**CITY OF WEST DES MOINES  
PLAN AND ZONING COMMISSION COMMUNICATION**

**Item:** Covenant Cove Plat 2, 9637 Heightsview Drive – Replat 22 lots into 21 lots and Approve a Site Plan to allow construction of ranch townhome design – Covenant Cove LLC - PP-004940-2020/SP-004941-2020

**Requested Action:** Recommend Approval of Preliminary Plat and Site Plan

**COVENANT COVE PLAT 2**  
**DIMENSION AND UTILITY PLAN**  
**SNYDER & ASSOCIATES, INC. I**

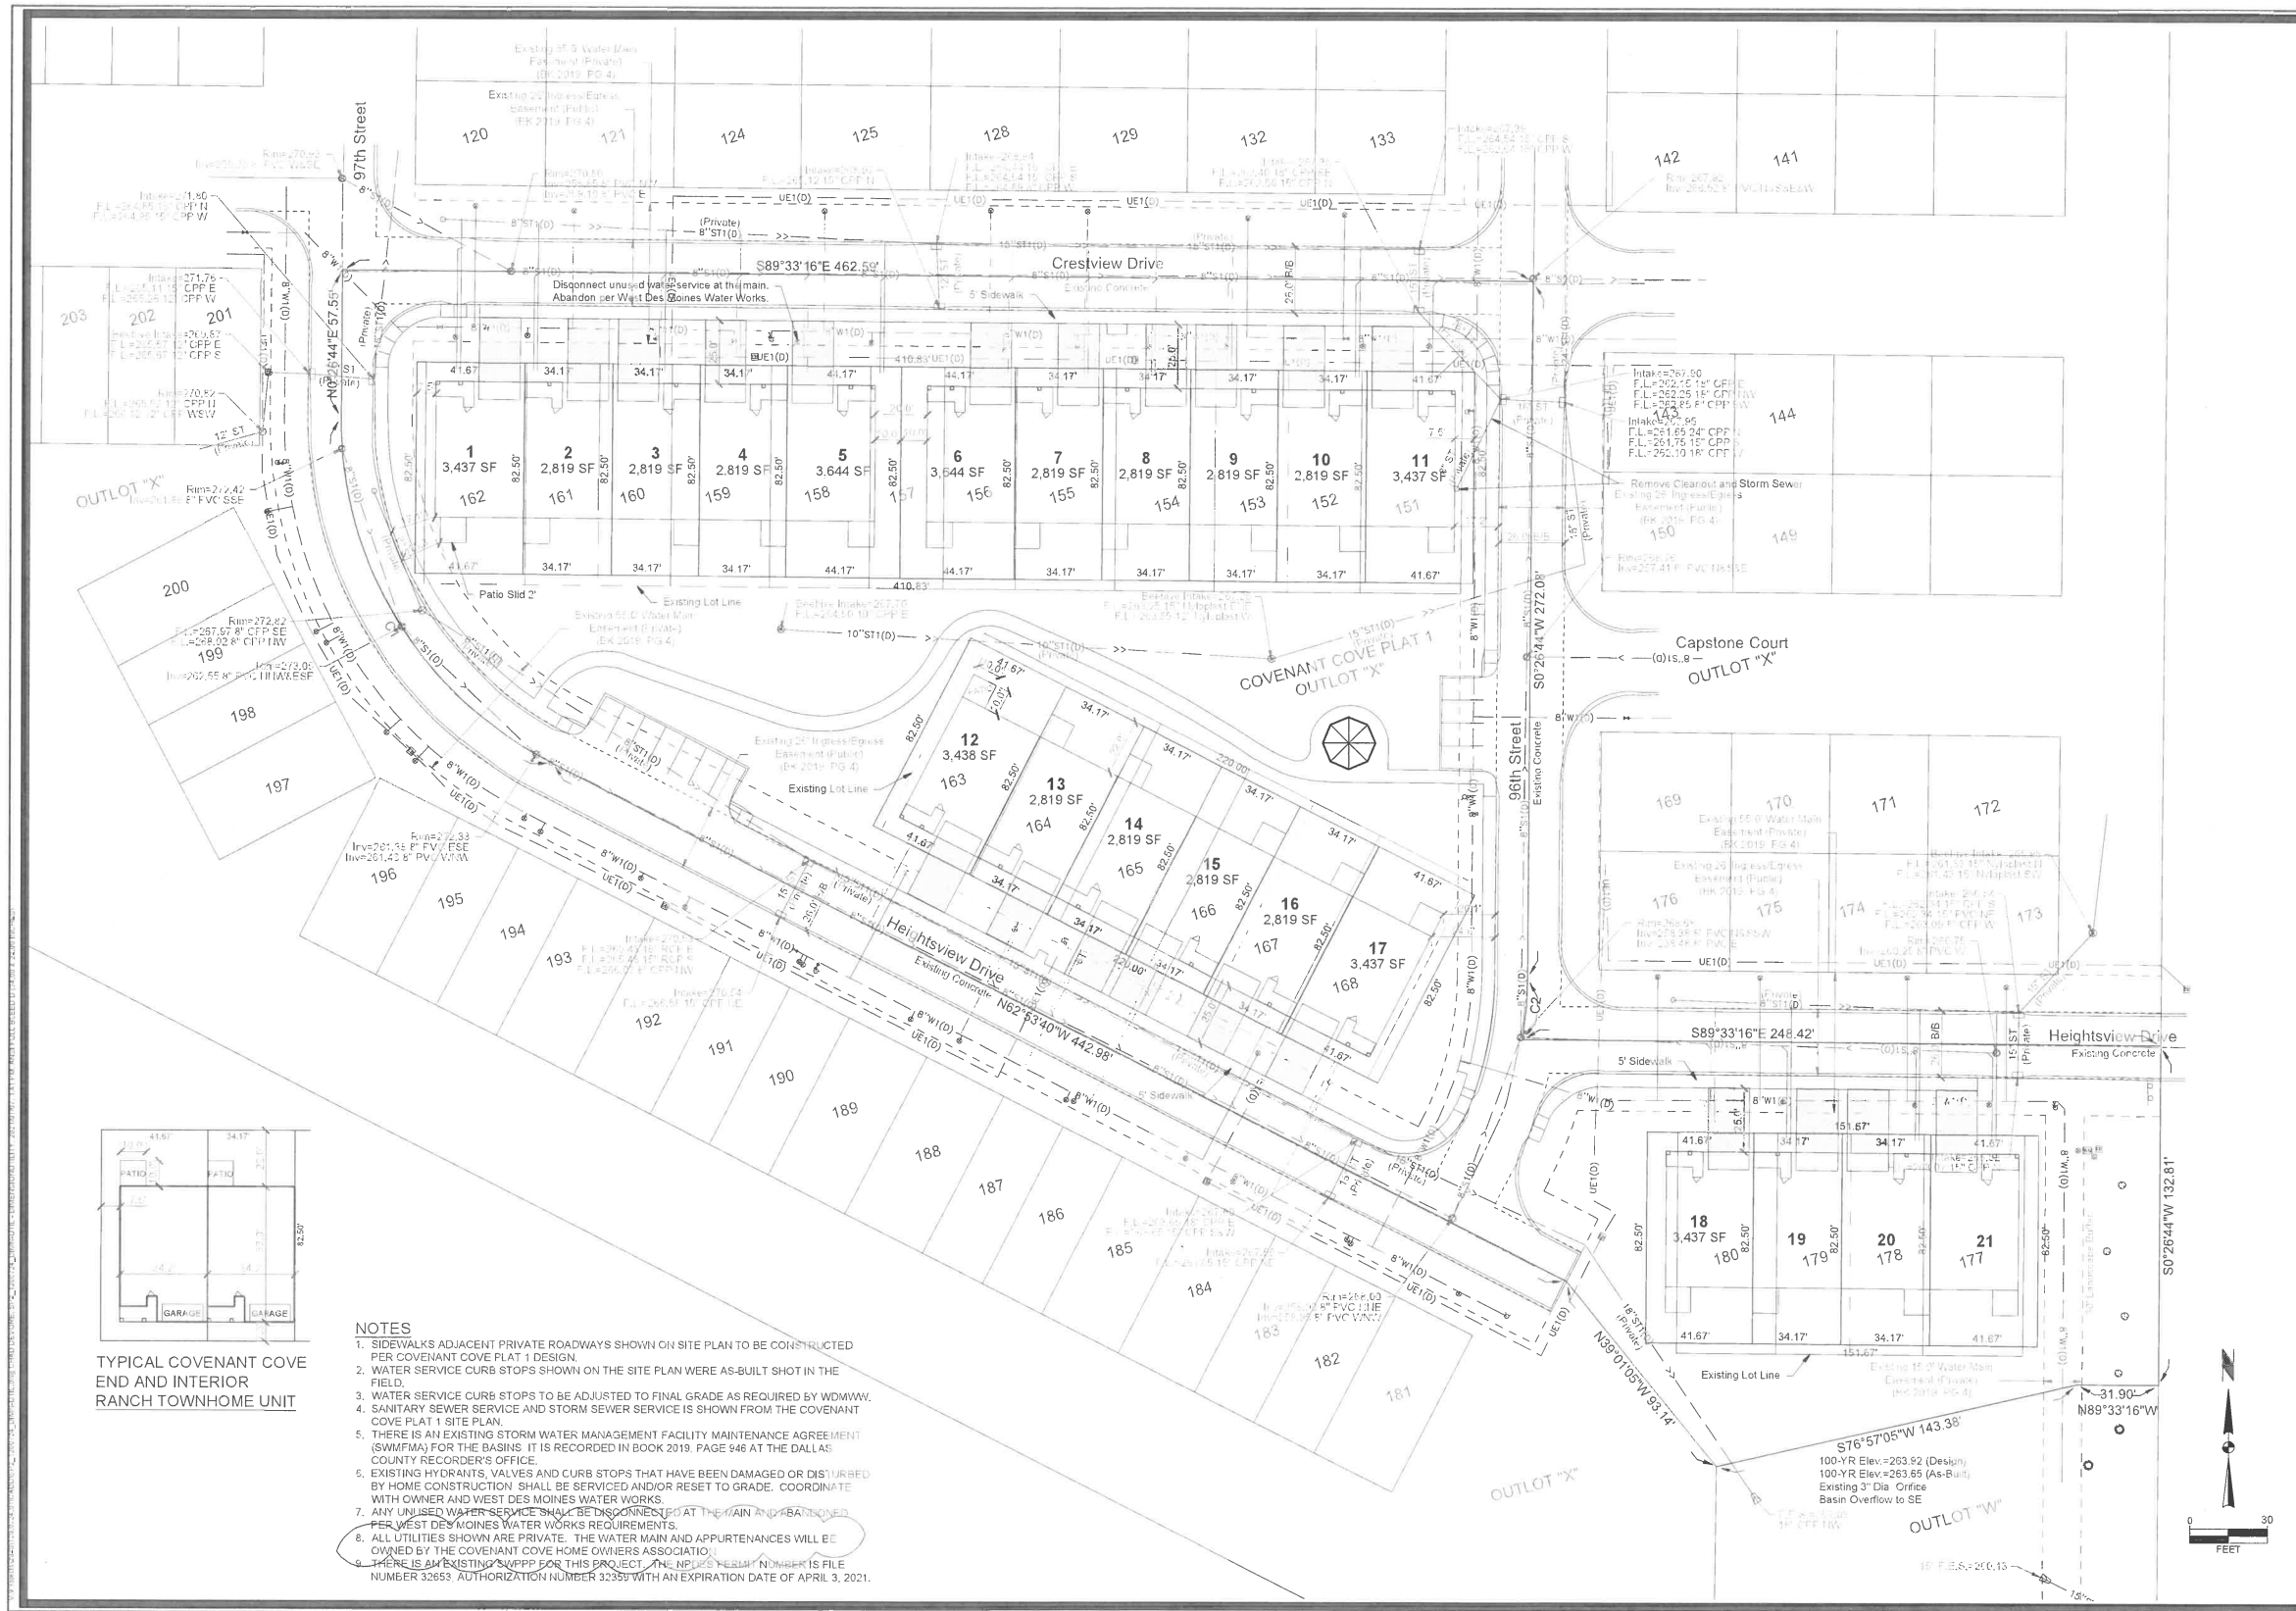
**Water Infrastructure:** Many of the hydrants, water valves and curb stops on the original plat have been damaged or disturbed as building construction has progressed. The original contractor is not returning West Des Moines Water Works' calls. It is strongly advised that the owner service and reset this infrastructure to grade so that this infrastructure, which is privately owned, can perform as desired in the event of an emergency. The West Des Moines Water Works is trying to communicate with the developer and requests that the final plat not be approved for this plat until the plan or work on these issues is resolved to the satisfaction of the West Des Moines Water Works. To encourage attention to this matter, in addition to not approving the final plat, staff recommends extending to clarify that no building permits, including footing and foundation permits shall be issued for structures on any of the 21 lots until water issues have been resolved to the satisfaction of WDM Water Works.

1. That the City Council agree to a condition of approval that the final plat for Covenant Cove Plat 2 not be considered and no building permits, including footing and foundation permits shall be issued for a structure on any of the 21 proposed lots until such time that the water infrastructure in Covenant Cove Plat 1 is repaired or a plan for repair to the satisfaction of the West Des Moines Water Works has been provided.

6. EXISTING HYDRANTS, VALVES AND CURB STOPS THAT HAVE BEEN DAMAGED OR DISTURBED BY HOME CONSTRUCTION SHALL BE SERVICED AND/OR RESET TO GRADE. COORDINATE WITH OWNER AND WEST DES MOINES WATER WORKS.
